WATER
RESOURCES
DEPARTMENT

REQUEST FOR WRITTEN APPROVAL TO USE CONSTRUCTION METHODS NOT
INCLUDED IN OREGON ADMINISTRATIVE RULES 690-200 THROUGH 690-240

2. Start Card Number(s): 89247

2. Start Card Number(s): ~~89247~~ 104086

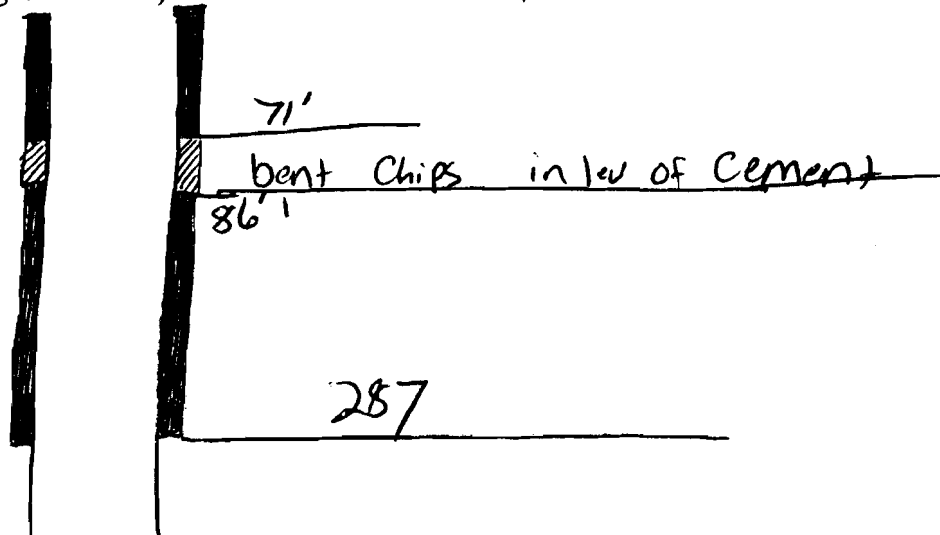
4. The unusual conditions which necessitate this request Grout loss

5. The proposed construction methods that the well constructor believes will be adequate for this well (attach additional pages if needed). Install bentonite chips for
17^{feet} ~~inch~~ to seal up zone that was taking grout.

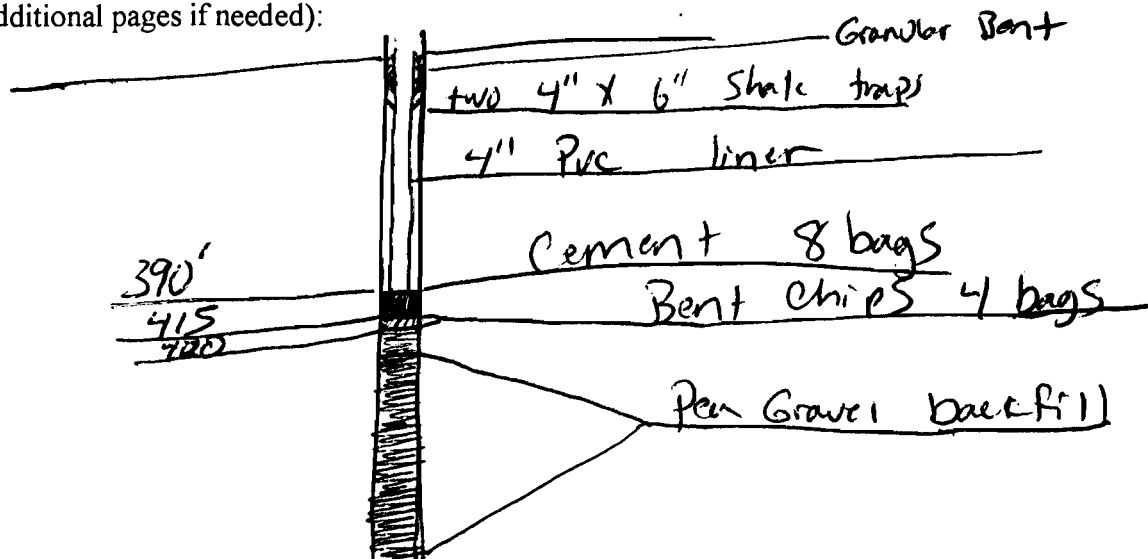
4. The unusual conditions which necessitate this request Two aquifers were
encountered with different states

5. The proposed construction methods that the well constructor believes will be adequate for this well (attach additional pages if needed). Plug the well with cement at
approximately 400' to separate the two aquifers and utilize upper one use shale traps
and granular bentonite to seal off cascading water at approximately 30 feet.

W
OT
Remarks: PVC inner casing with shale traps
